MYERS CHUCK HARBOR FACILITIES PROJECT NO. K-31521

AS BUILT

START : MAY 31, 1985
STOP : JULY 9, 1985
CONTRACTOR : DAWSON CONSTRUCTION CO.
PROJECT ENGINEER : MARK HALVORSEN
DATE : JULY 19, 1985

STAMP		DO NOT SCALE THIS DRAWING - USE DIMENSIONS	
STATE OF ALASKA			
DEPARTMENT OF TRANSPORTATION AND PUBLIC FACILITIES			
Myers Chuck		Alaska	
SEAPLANE FLOAT RECONSTRUCTION & GANGWAY FLOAT MODIFICATIONS			
DESIGNED RPB	CHECKED JDB	DRAWN TS	DATE 8/84
PROJECT NUMBER K-31521		SHEET 7 OF 7

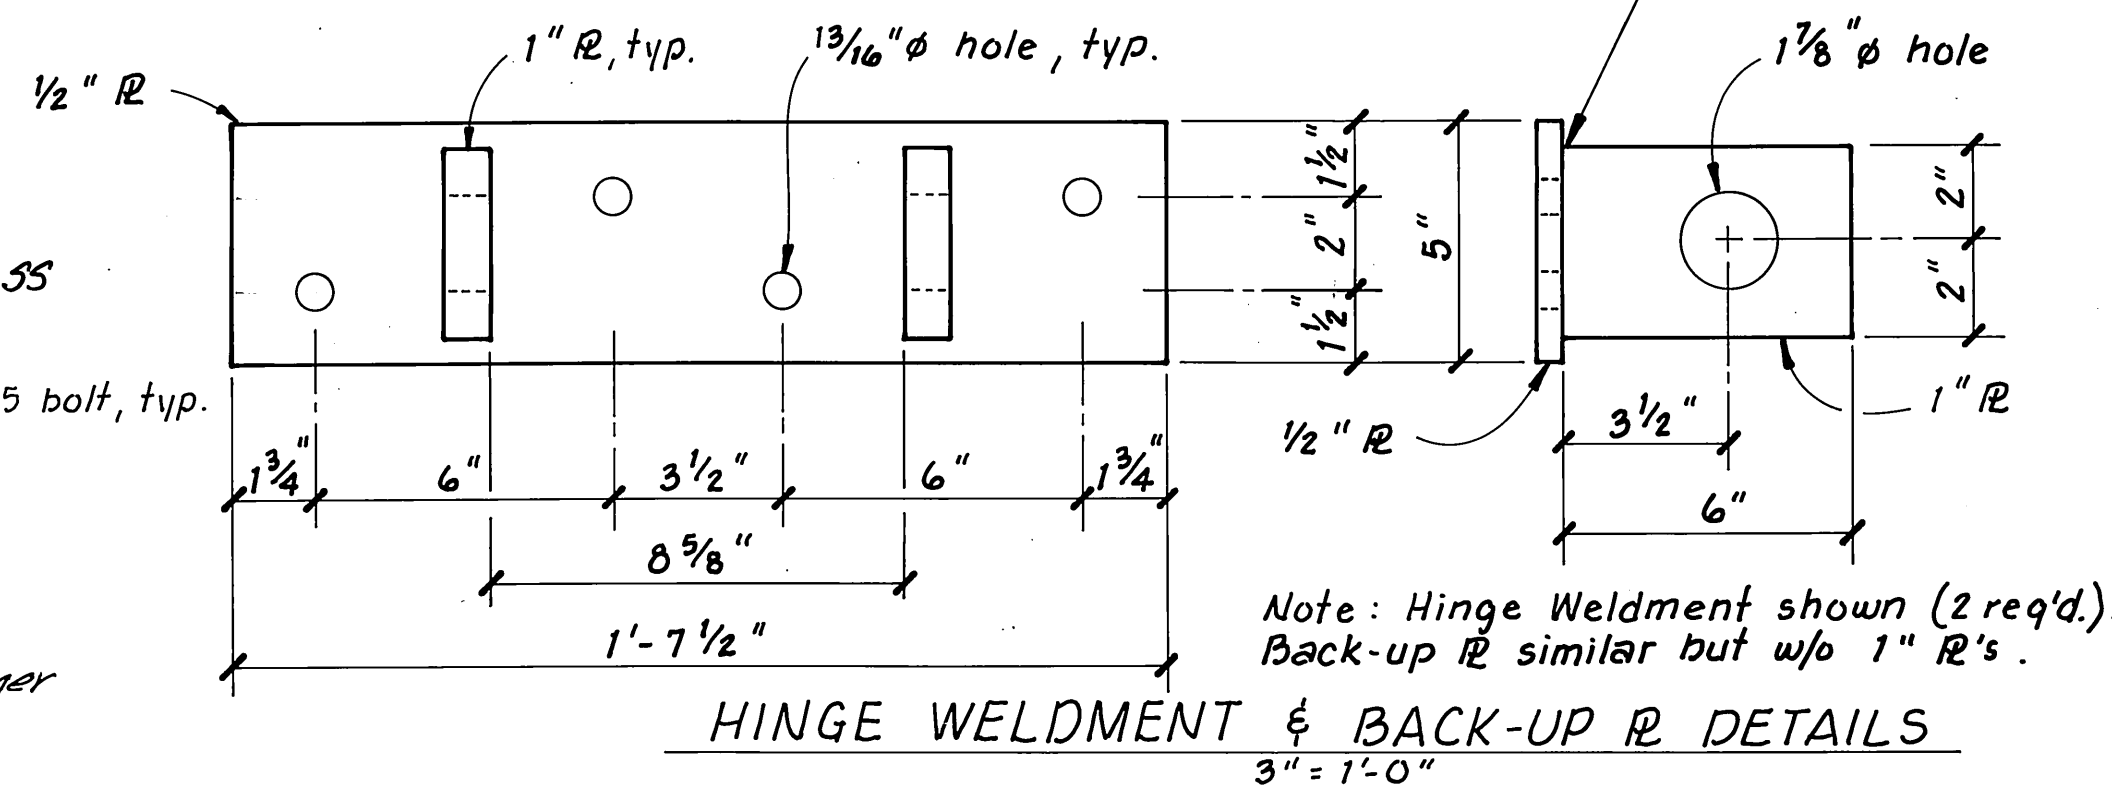
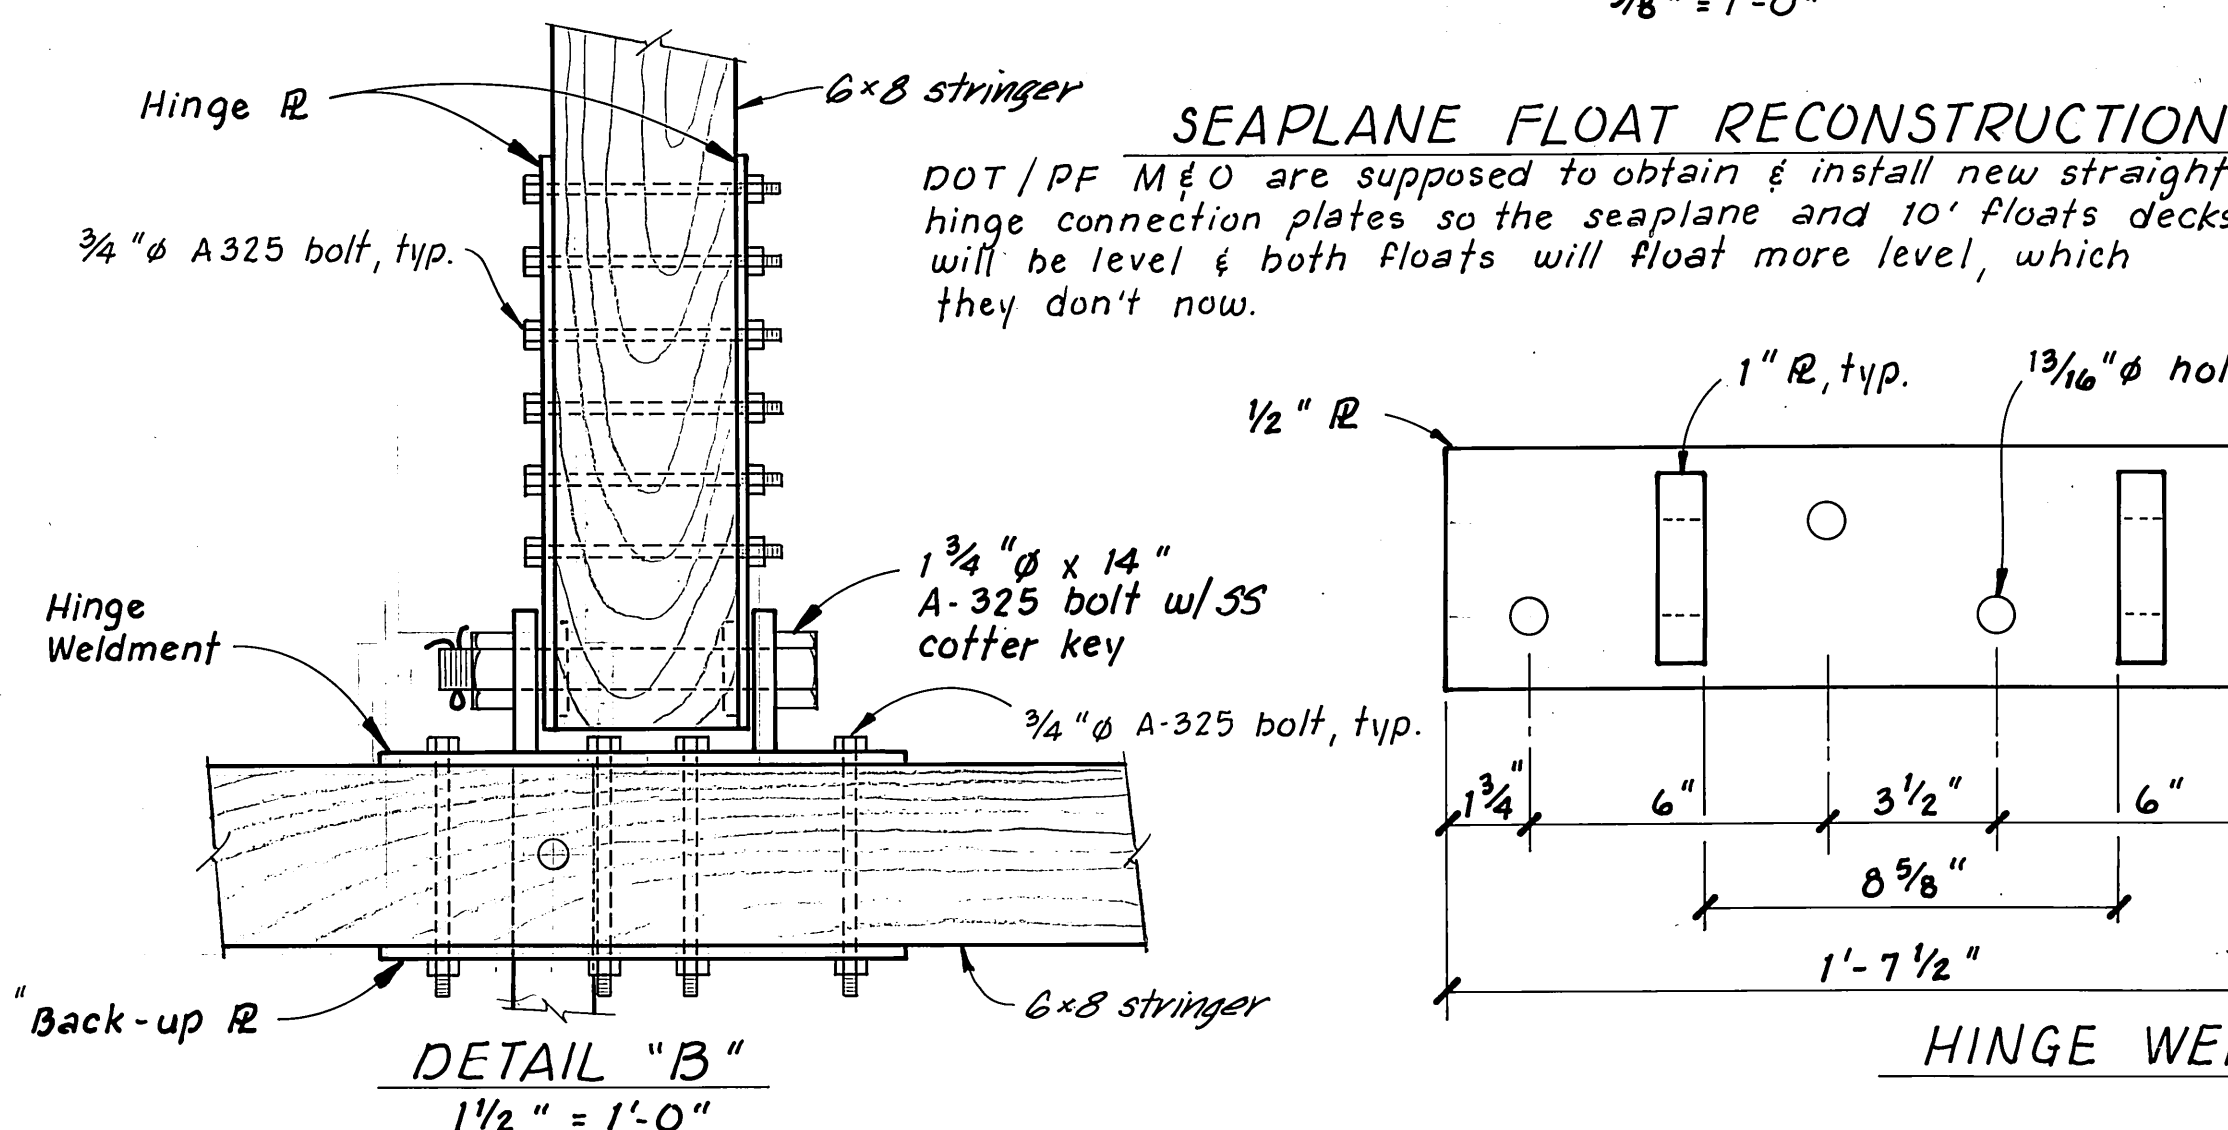
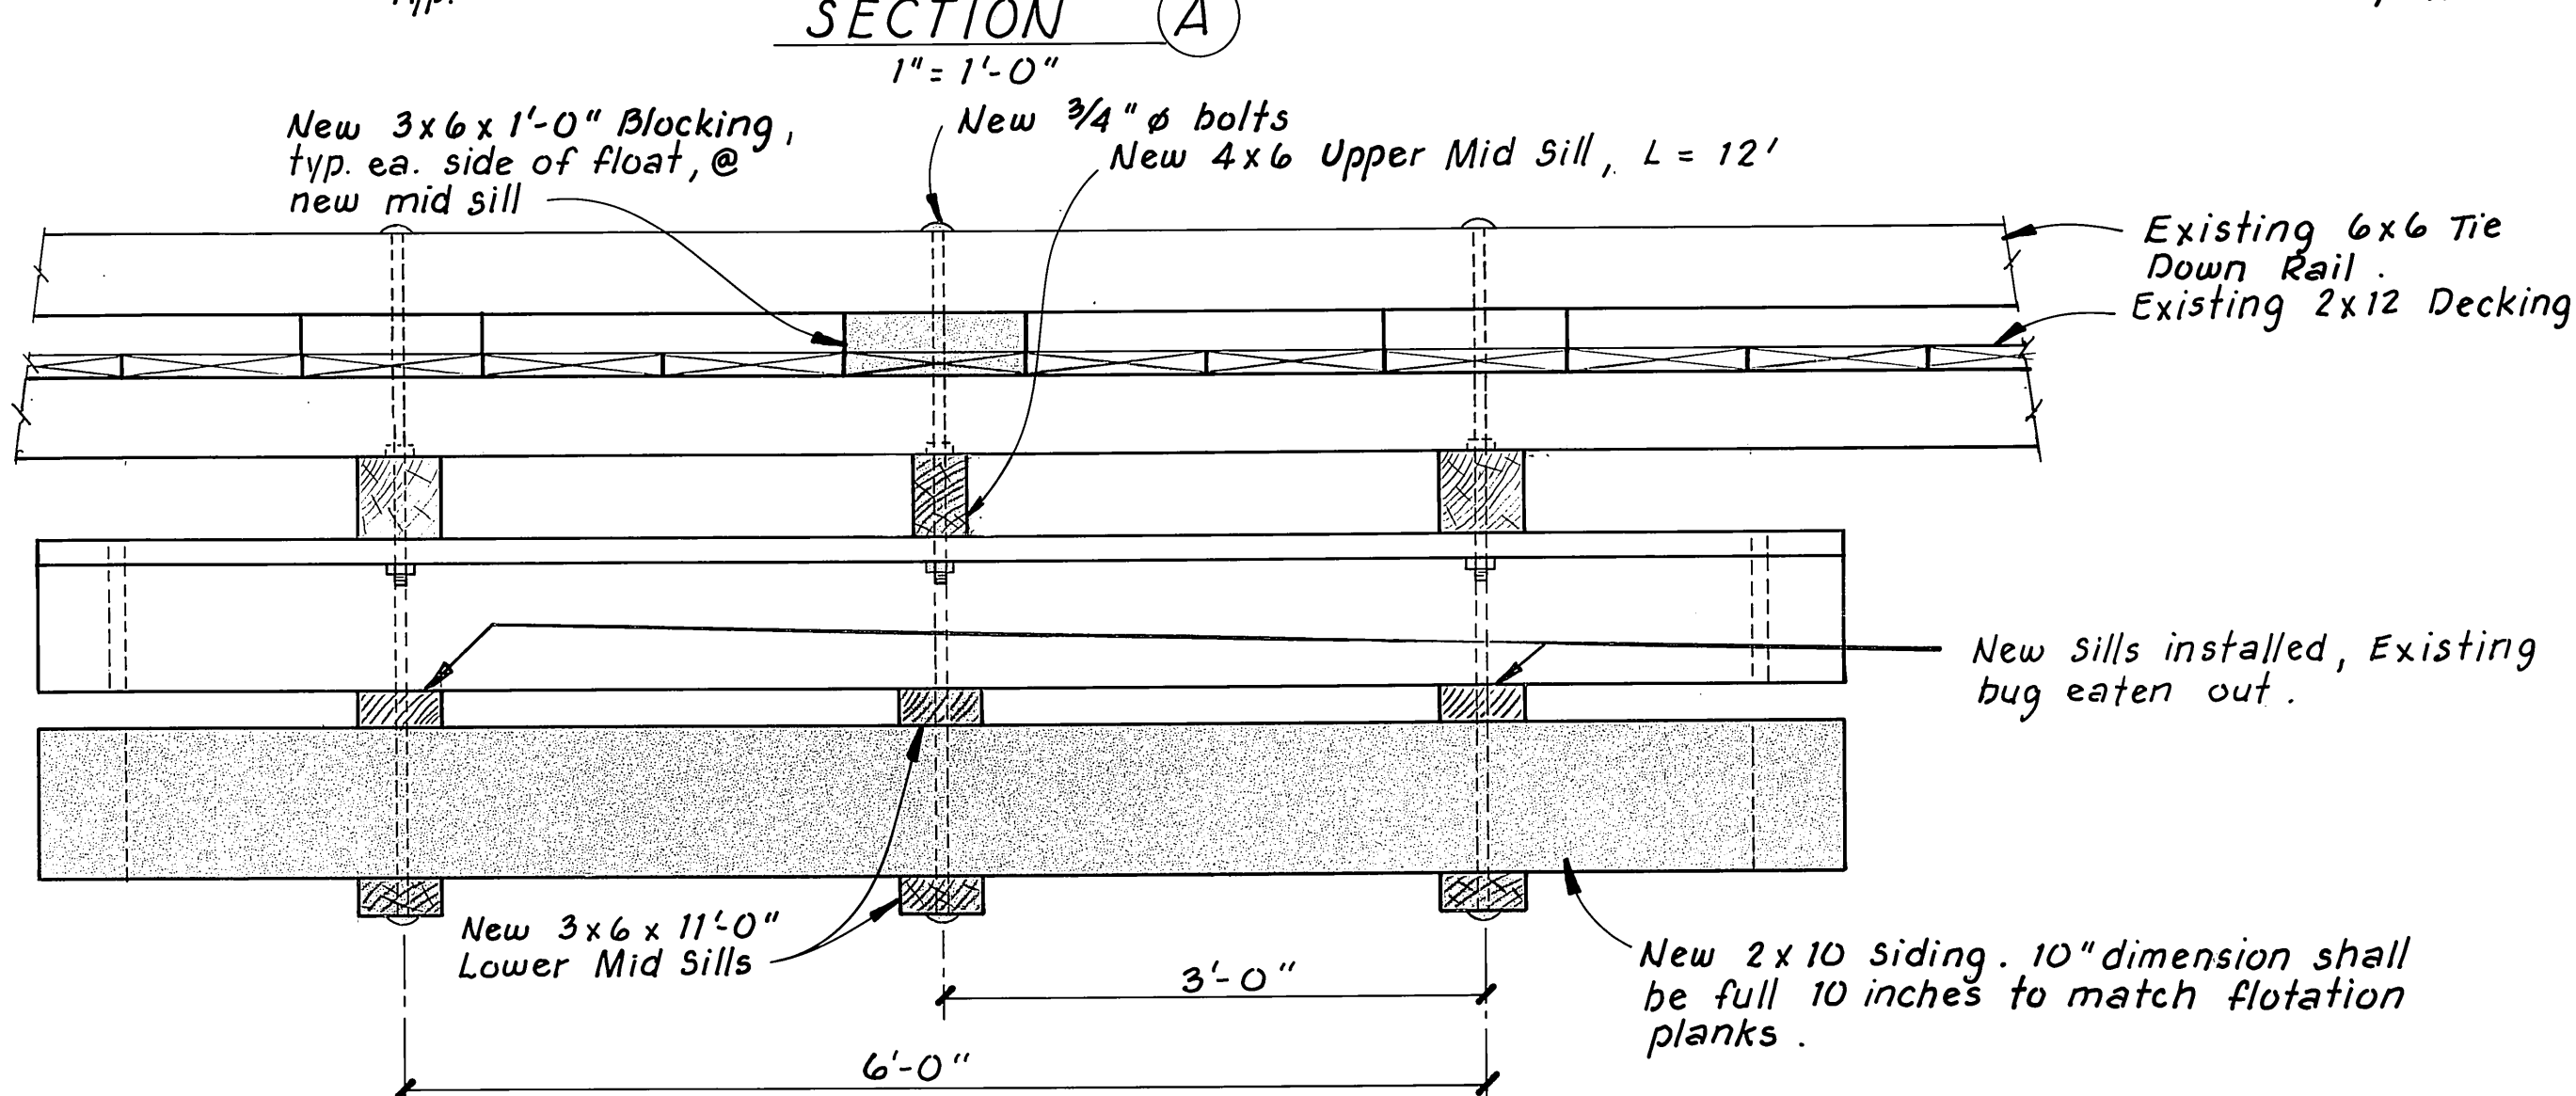
Left this stringer in place for added support.
All underwater portions of the 4x10 Sills & all of the bottom stringers are badly bug eaten. The existing foam is also badly eaten. The bottom ends of the galv. bolts are corroding out. The foam billets this location installed on edge.

Extra piece of new foam installed in this pontoon. Came from next pontoon in line, see note on page 2.
